# SERVICE BULLETIN **Buell**<sup>®</sup>

B-030

## SAFETY RECALL CODE 0818 - 1999 S3 REAR BRAKE LINE

Figure 3. Original Clamp and Brake Line

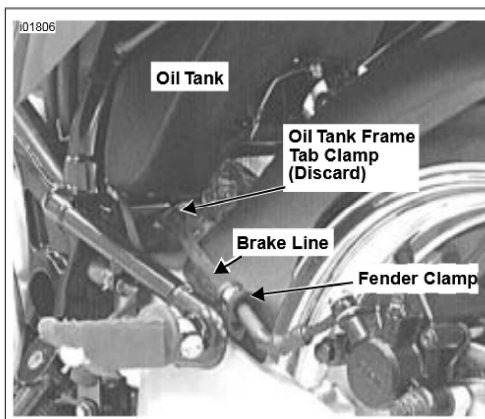
Buell Motorcycle Company has learned that certain 1999 S3 model motorcycles were built with a rear brake line located in a position that may cause it to become damaged. This condition could result in brake fluid loss. Should this occur the rider could experience loss of rear wheel braking capabilities. Accordingly, Buell Motorcycle Company is conducting a voluntary recall campaign to formally recall all potentially affected motorcycles.

6. See Figures 3 and 6. Remove screw to detach brake line clamp from lower left oil tank frame tab. Retain the bolt and washer for re-use. Discard clamp.

This condition will be remedied by replacing the rear brake line on all potentially affected vehicles.

Figure 4. Wireform Installation

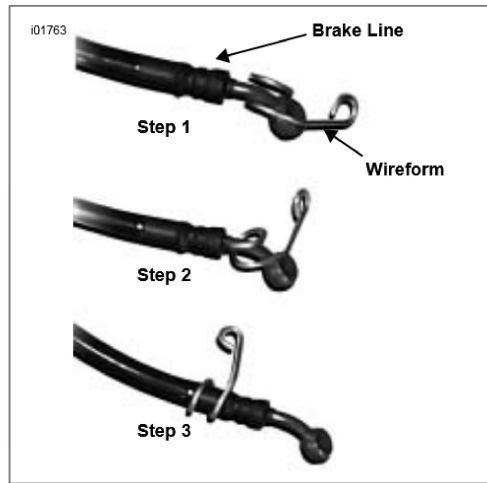
2. See Figures 4 and 6. Install the wireform onto the **new** brake line as shown.
3. From left side of vehicle, feed **new** brake line from rear brake caliper mount forward to frame mount. Route brake line to the right towards rear master cylinder.

Figure 5. New Wireform and Brake Line

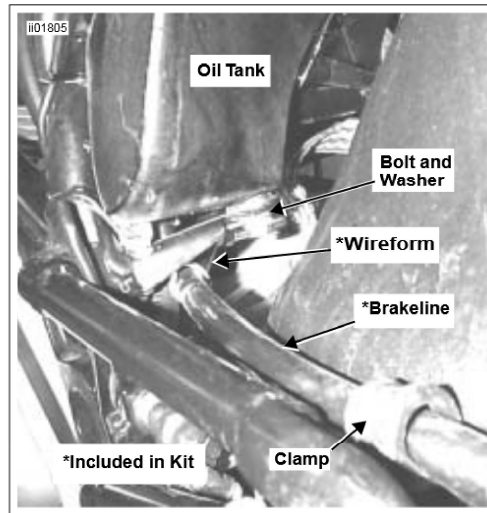
6. See Figures 5 and 6. Install **new** wireform to lower left oil tank tab with original washer and bolt. Washer goes between bolt and wireform.

Figure 6. Brake Line with Clamps and Wireforms

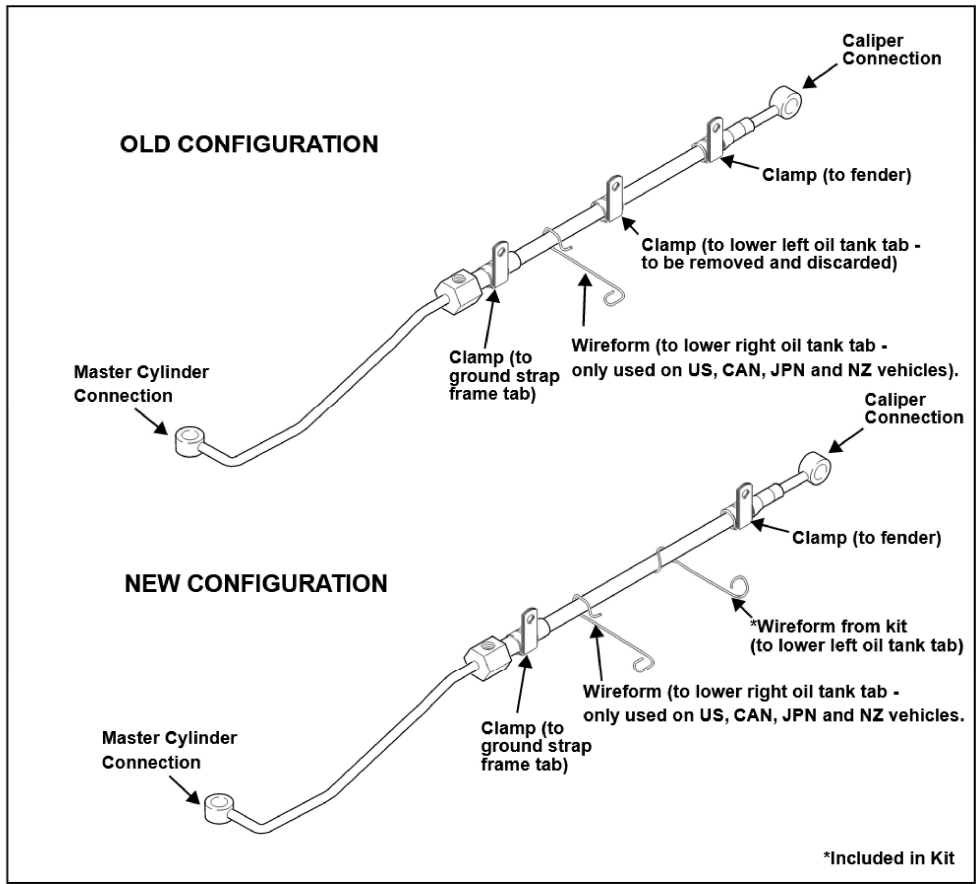
4. See Figures 2 and 6. If applicable, attach brake line to wireform on lower right oil tank tab.
5. See Figures 2 and 6. Install screw and clamp (1) to fasten rear brake line ground strap and star washer to frame tube on right side of motorcycle. Tighten to 10-12 ft-lbs (13.6-16.2 Nm). Note: Star washer goes between ground strap and frame tab.
